<u>SP-24-09</u>	<b>Staff Report – July 29, 2024</b>
<b>Application Type:</b>	Special Use Permit
<b>Project Address:</b>	1601 Lemoyne Avenue (Tax Map ID: 004.-05-03.0), 1611 Lemoyne Avenue To City Line, (Tax Map ID: 004.-05-02.0), 1585 Lemoyne Avenue (Tax Map ID: 004.-05-04.1)
<b>Summary of Proposed Action:</b>	<p>The applicant (Cuse Car Care, LLC.) proposes to change the land use from a heavy automobile repair use type to a light automobile repair use type and build a 2,920 SF (footprint) addition onto the existing building. The existing heavy automobile repair use type is a legal non-conforming land use in the Mixed-Use Transition, MX-3 Zone District. The light automobile repair use type is a conforming use and only permitted by a Special Use Permit in the MX-3 Zone District.</p> <p>The applicant also intends to combine three existing lots (1601 Lemoyne Ave., 1611 Lemoyne Ave., and 1585 Lemoyne Ave.) to become one new lot (new 1601 Lemoyne Ave.) for the proposed light automobile repair use and proposed building expansion.</p> <p>The total gross floor area of the proposed building is 5,840 SF (2-story) and the existing building is 3,165 SF (1 story). The total gross floor area of t

SHEET NUMBER  
**L-1**

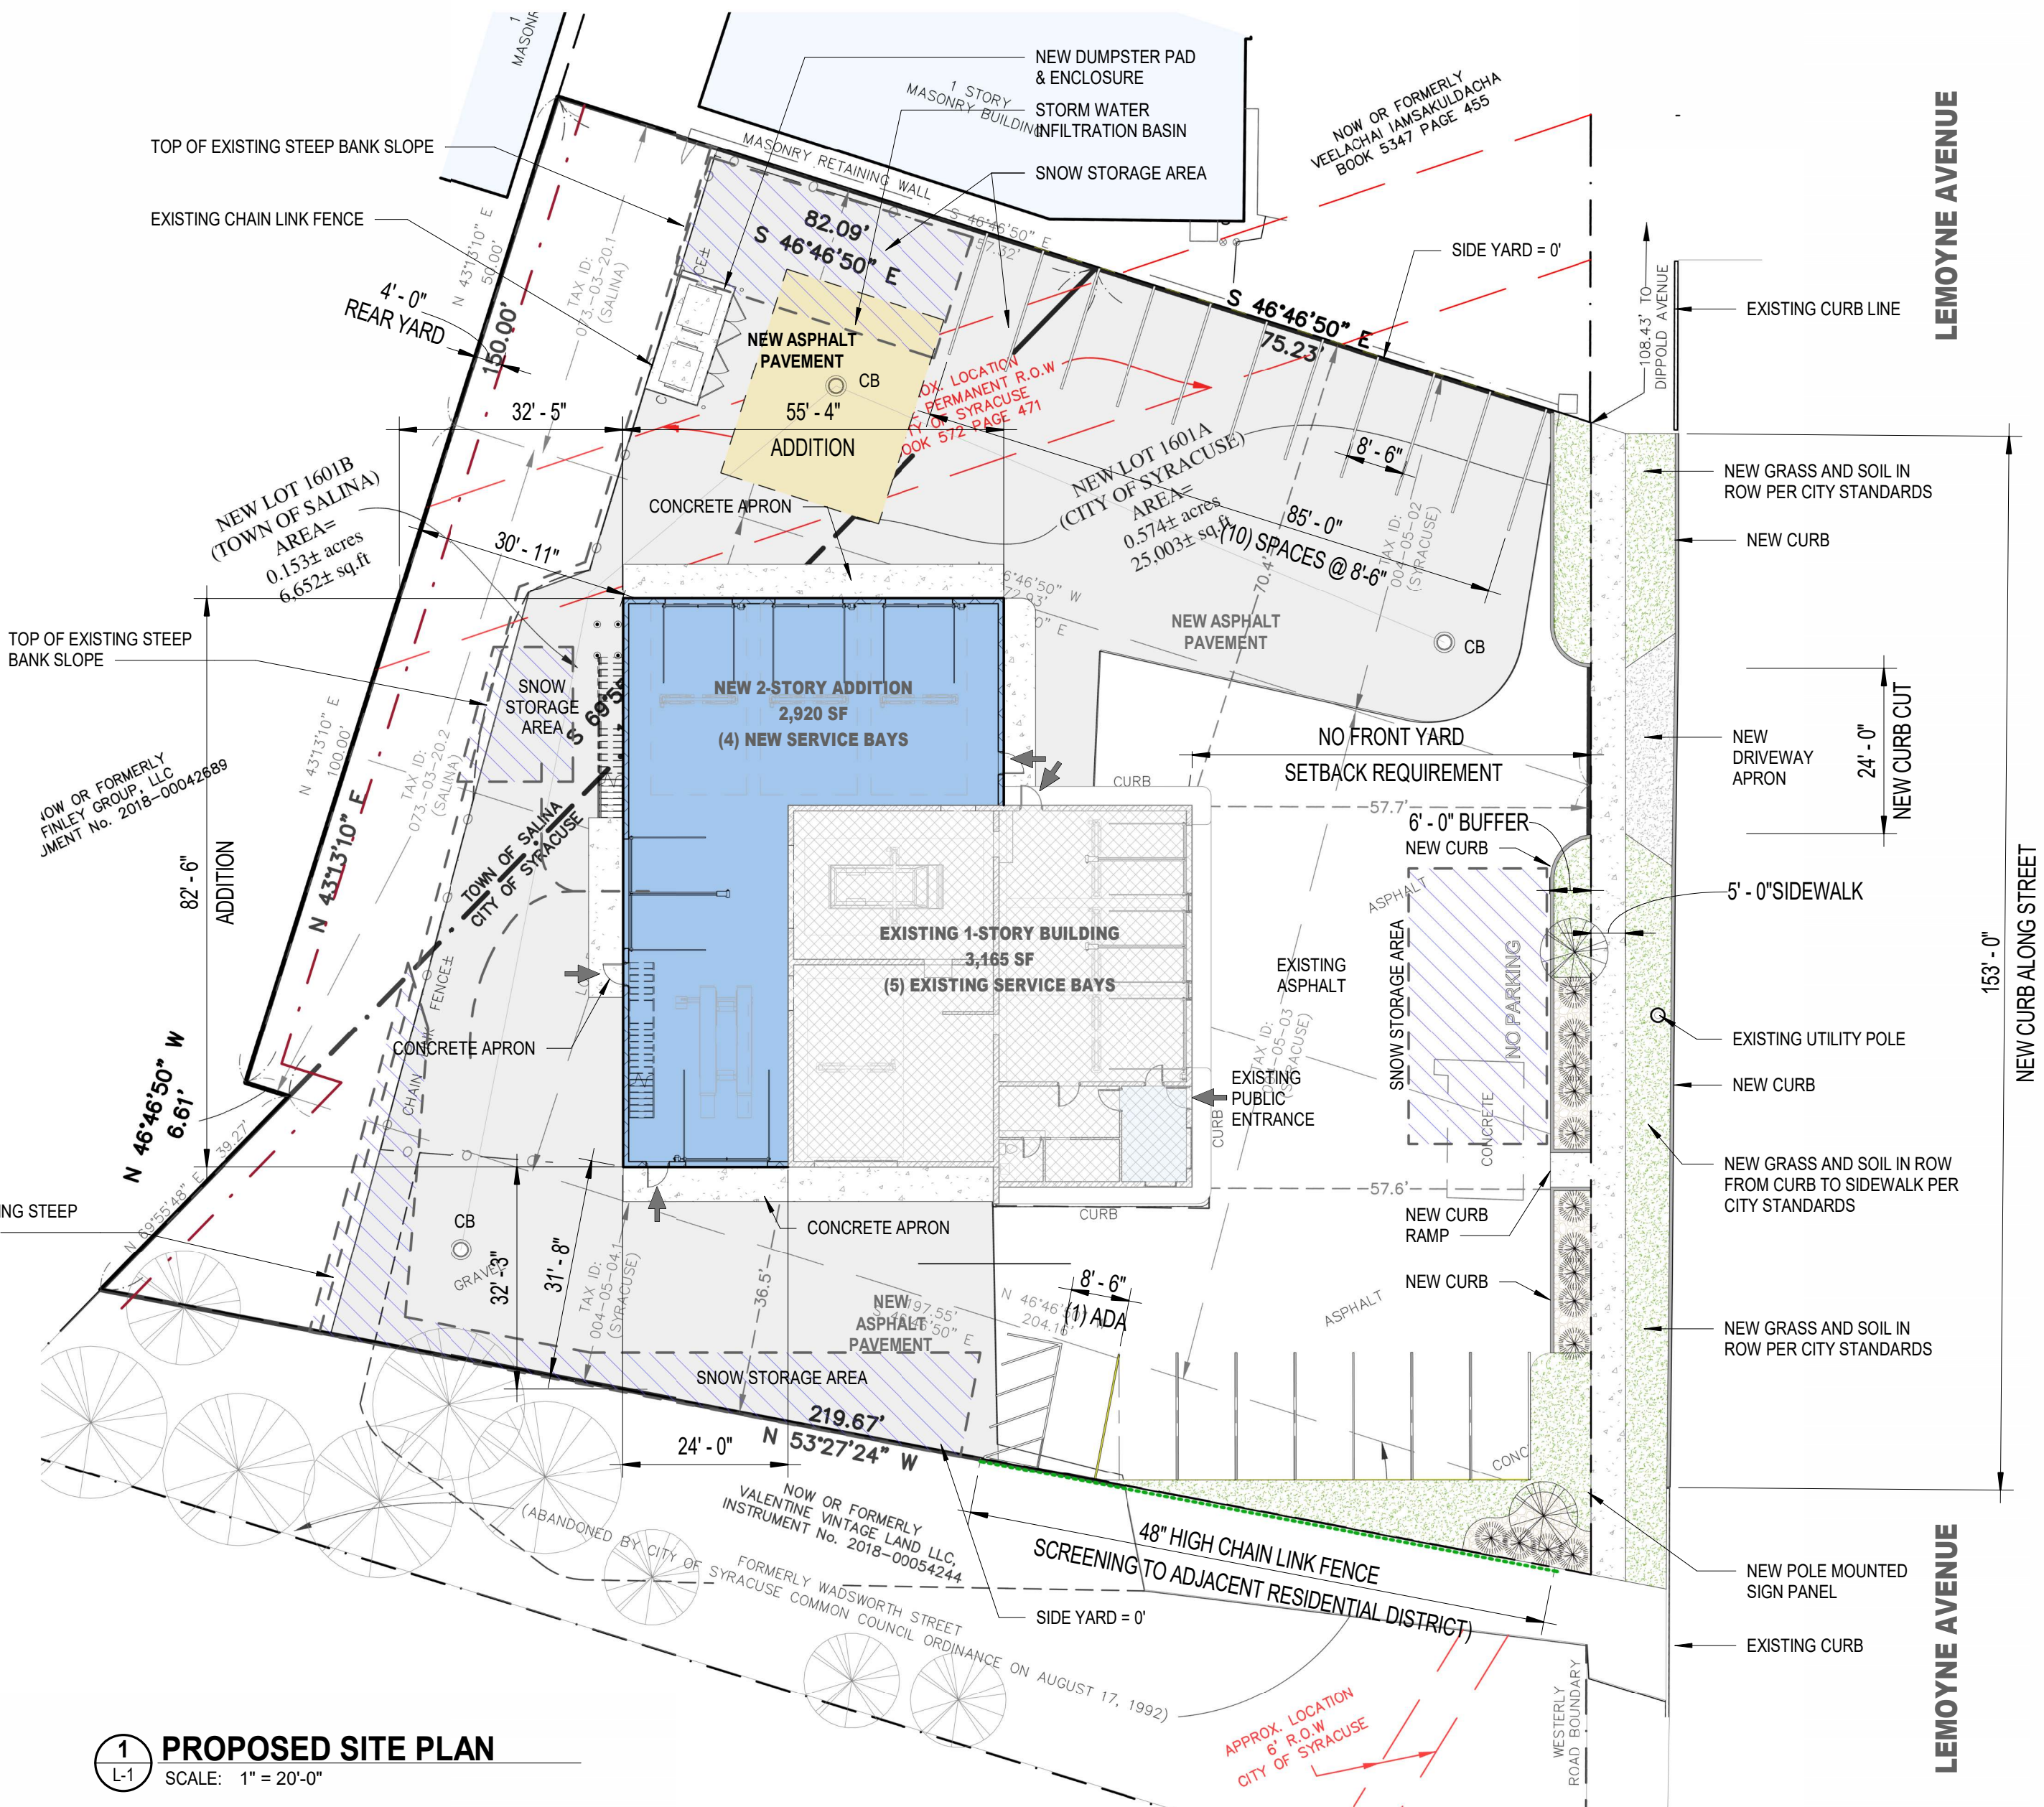
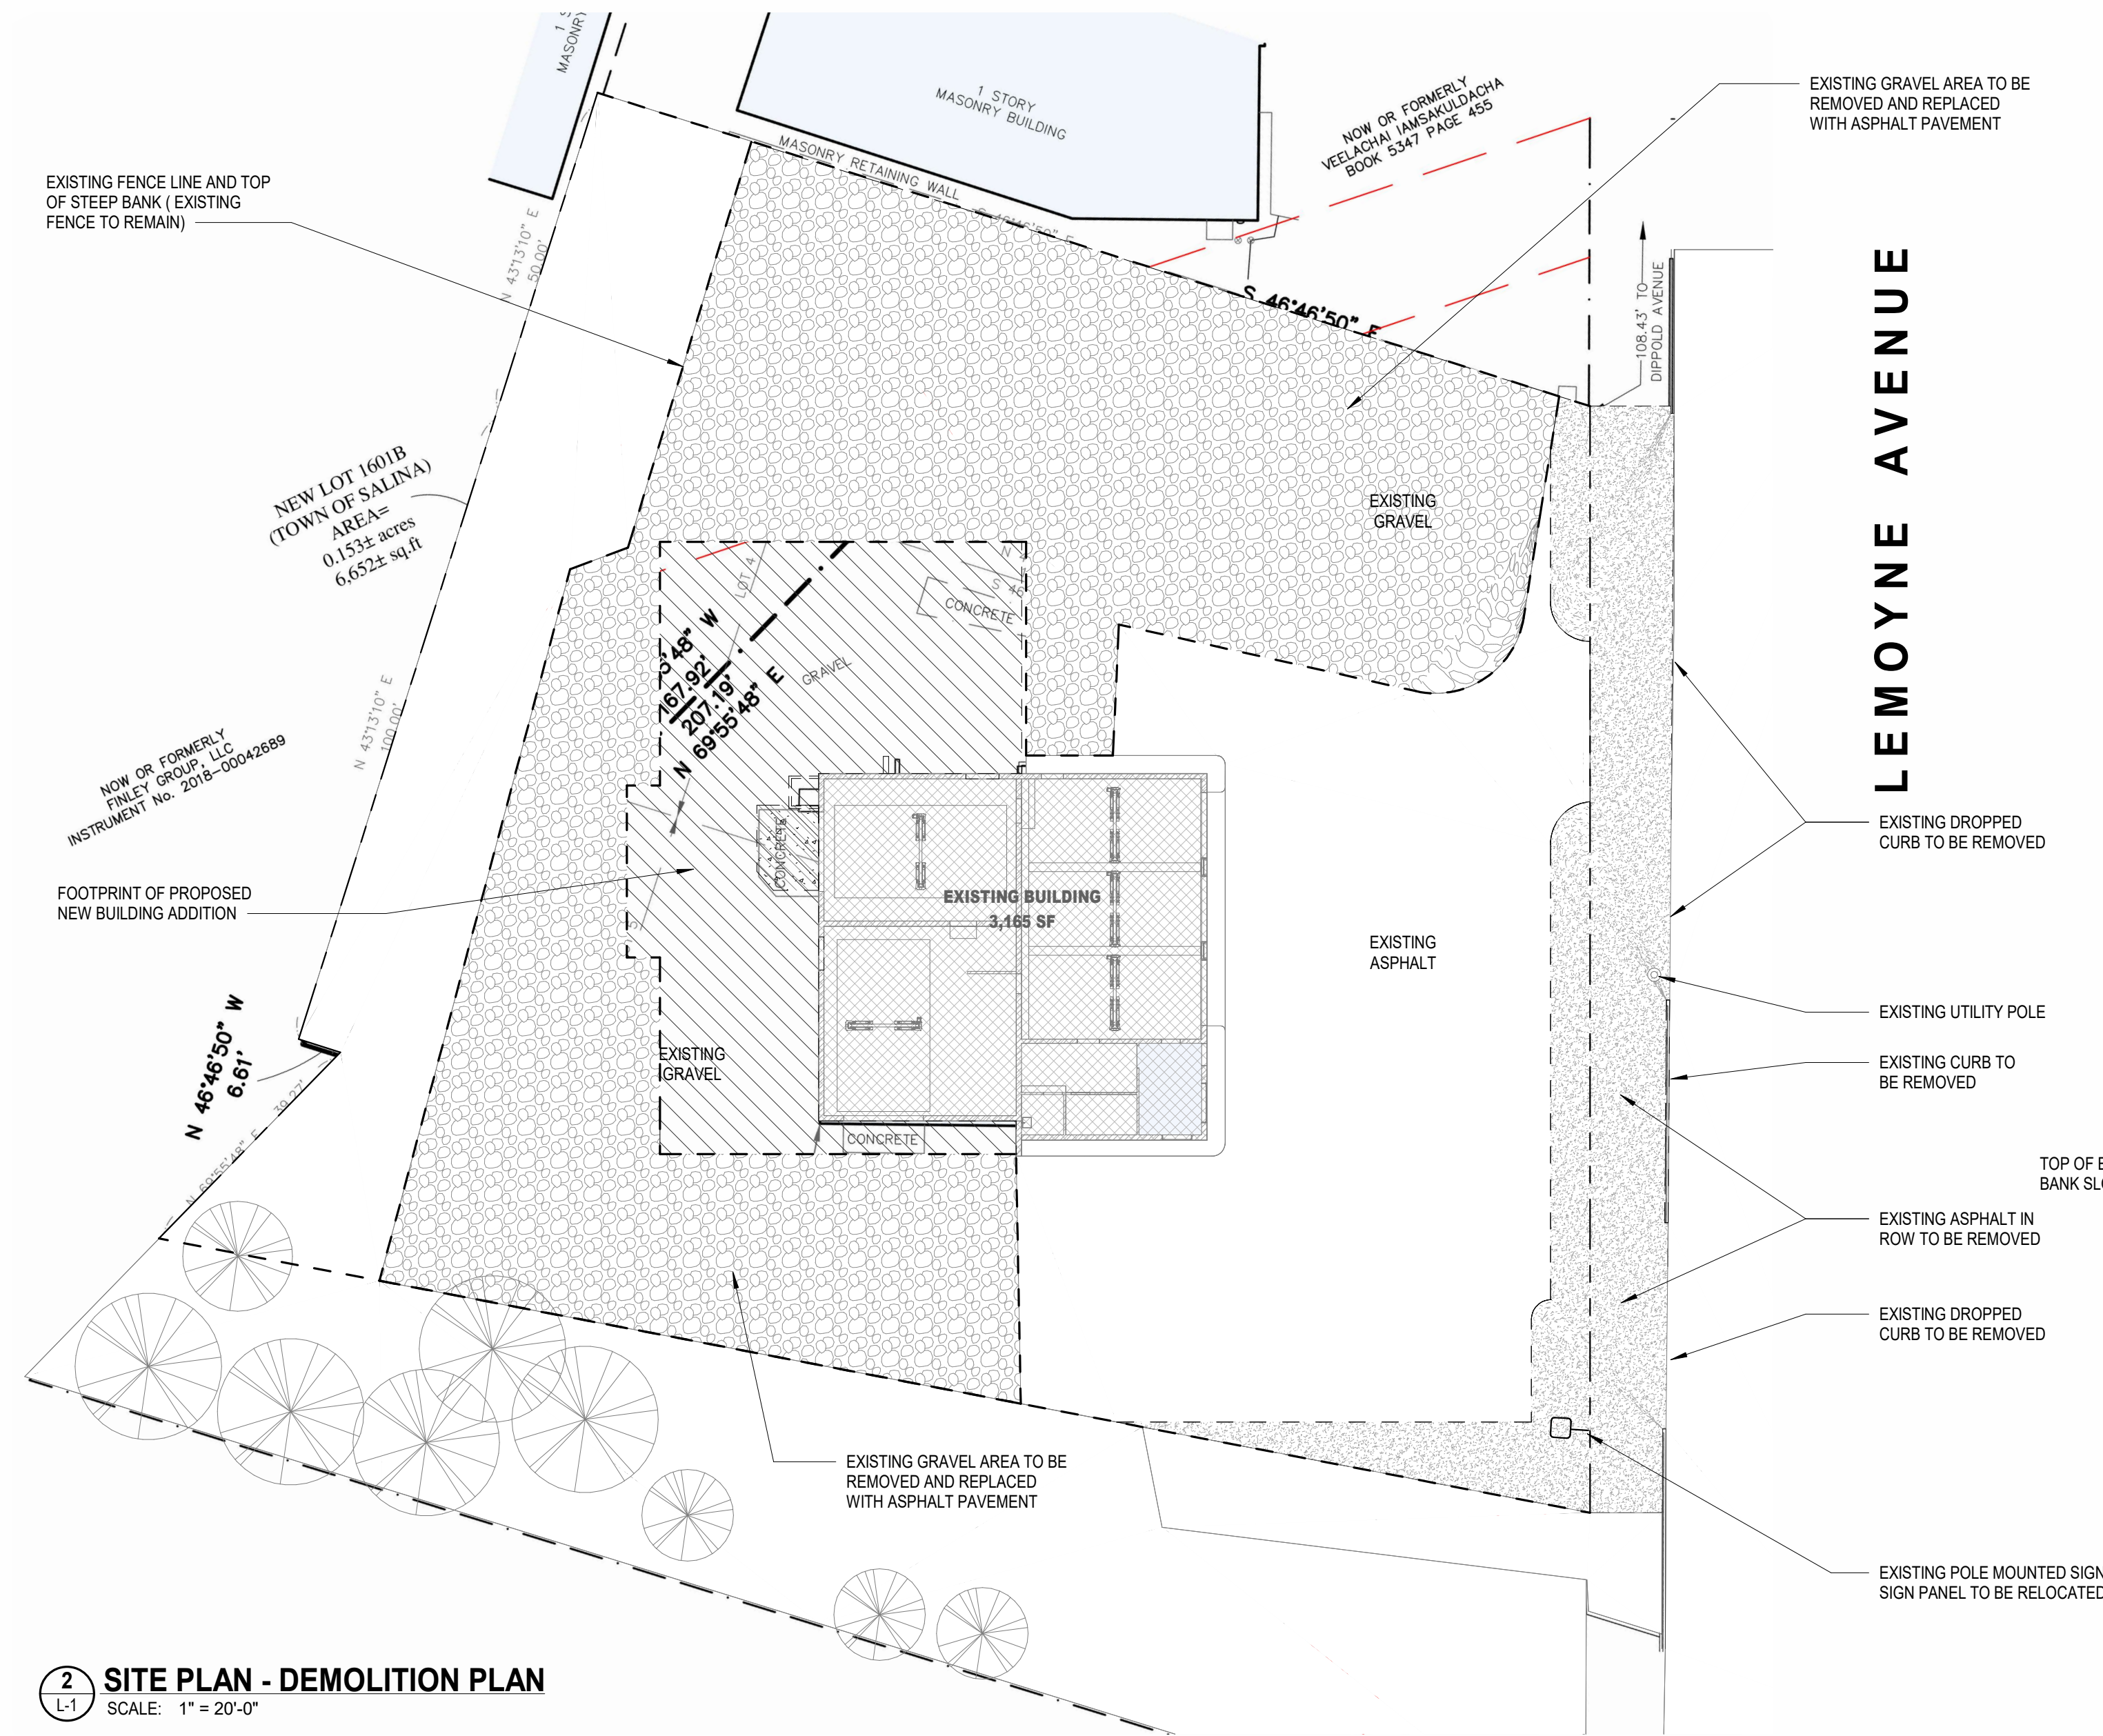
- WHEREAS, per the Site Plans, the applicant is proposing construction of a 2,920 sf 2-story addition to the northeastern and northwestern sides of the existing building which will allow construction of four new service bays in addition to the existing five bays, second floor offices, breakroom, and storage; gravel will be replaced with new asphalt, a dumpster enclosure constructed, and striping of 17 parking spaces along the southwestern and northeastern site boundaries; the Site Plans do not depict any changes in access to the site, plantings, or increase in permeable surface; and

will not result in additional stormwater; the Site Plan depicts 3 catch basins located in the parking lot; and

1. The applicant is required to coordinate with the Onondaga County Department of Transportation regarding access plans and establish formal driveway access to LeMoyne Avenue in conformance with commercial driveway standards. The municipality must ensure any mitigation as may be determined by the Department is reflected on the project plans prior to, or as a condition of, municipal approval.
2. The applicant and City must coordinate a multi-municipal review of the proposed project with the Town of Salina.
3. The applicant and municipality are encouraged to improve appearance of the

site while improving stormwater conditions by adding landscaping and plantings along the road frontage and parcel boundaries, adding bioswales and planting islands, and/or utilizing permeable pavement on site.

1. The applicant is required to coordinate with the Onondaga County Department of Transportation regarding access plans and establish formal driveway access to LeMoyne Avenue in conformance with commercial driveway standards. The municipality must ensure any mitigation as may be determined by the Department is reflected on the project plans prior to, or as a condition of, municipal approval.
2. The applicant and City must coordinate a multi-municipal review of the proposed Site Plan with the Town of Salina.

The applicant and municipality are encouraged to improve appearance of the site while improving stormwater conditions by adding landscaping and plantings along the road frontage and parcel boundaries, adding bioswales and planting islands, and/or utilizing permeable pavement on site.

Approval	Status	Status Date	Reviewer	Comments
DPW - Transportation Planner	Conditionally Approved	06/25/2024	Neil Milcarek-Burke	<p>Revised plans address previous comments.</p> <ul style="list-style-type: none"> <li>- Applicant to ensure that cross access with neighboring parcels is restricted unless agreement in place, and parking areas along southern property line incorporate bollards or other fixed objects (no wheel stops) to prevent parking on grass.</li> </ul> <p>Revised plans required. Current site is hazardous to pedestrians and other traveling public due to lack of channelization for vehicle ingress/egress at a high-volume signalized intersection of an Arterial and Major Collector.</p> <ul style="list-style-type: none"> <li>- Parcel to conform to 24' max width curb-cut, current site plan shows ~120' feet total curb-cut. All other areas outside typical 24' opening to be restored to full reveal granite curb.</li> <li>- Concrete sidewalk required required across Lemoyne Ave frontage, including across driveway. Walk to be located at property line.</li> <li>- Asphalt is not a permissible ground cover material in the ROW, all asphalt in the ROW is to be removed and area restored to topsoil &amp; grass, outside of revised driveway opening. Area between sidewalk and curbline should be grass, and incorporate any requirements per Forestry Department.</li> <li>- Parking area/lot frontage to incorporate a guide rail or other fixed vertical objects (no wheel stops), other than</li> </ul>

- Parking area to be curbed/incorporate fixed vertical objects (no wheel stops) along all sides.
- Parking area to incorporate greenspace buffer, 5' or greater along entirety of Lemoyne ave frontage outside of driveway opening, measured inwards from property line. To include perirenal plant material/trees/etc.
- Planting plan required, grading/drainage plan may impact/increase buffer requirements.
- ADA compliant walkway to/from the main entrance and public ROW/sidewalk required, typically aligned with loading area of accessible parking stalls.

DPW - Sanitation & Sewers	On Hold	04/17/2024	Vinny Esposito	<p>please provide a drainage plan, The site will be nearly 100% impervious as per plan. Storm water must be mediated to an extent, dry wells or re-charge trenches. Also the sewer in the 20' ROW must be located precisely as I believe this is a 30" storm sewer.</p>
DPW - Traffic Control	Conditionally	04/23/2024	Charles	4.23.24 Conditionally Approved.

Approved		Gafrancesco	No sidewalk closures or obstructions or road or lane closures will be allowed as part of this work unless accompanied by MUTCD compliant detour.
Zoning Planner	On Hold	04/17/2024	Haohui Pan	Updated plan needs: The east side of the building that abutting the adjacent Residential Zone shall be fenced.
Engineering - Stormwater (SWPPP)	Conditionally Approved	04/25/2024	Mirza Malkoc	<ul style="list-style-type: none"> <li>• All construction in the R.O.W. will require a road cut permit, all construction in the R.O.W. to be per City standards and specifications.</li> <li>• Complete set of the stamped engineering site plans with specific details are required to complete a detailed project permit review.</li> <li>• Designer shall clearly indicate on the site plans how much soil disturbance this project will create. If the soil disturbance is over 10,000sf then a SWPPP is required but if the soil disturbance is less than 10,000sf then the designer need to do some improvements to the site by capturing the stormwater sheet flow and treating it before discharging it to the City's ROW.</li> <li>• Proposed grading shall be graded to prevent stormwater sheet flow to adjoining properties &amp; to the City R.O.W.</li> <li>• The Project is subject to Onondaga County's 1:1 offset. The City requires an offset plan &amp; details for review. Applicant shall submit sanitary flow data to the Engineering Department, the determined offset plan then most likely will require Common Council Approval.</li> <li>• Onondaga County Plumbing Control shall review and approve the plans as well.</li> </ul>
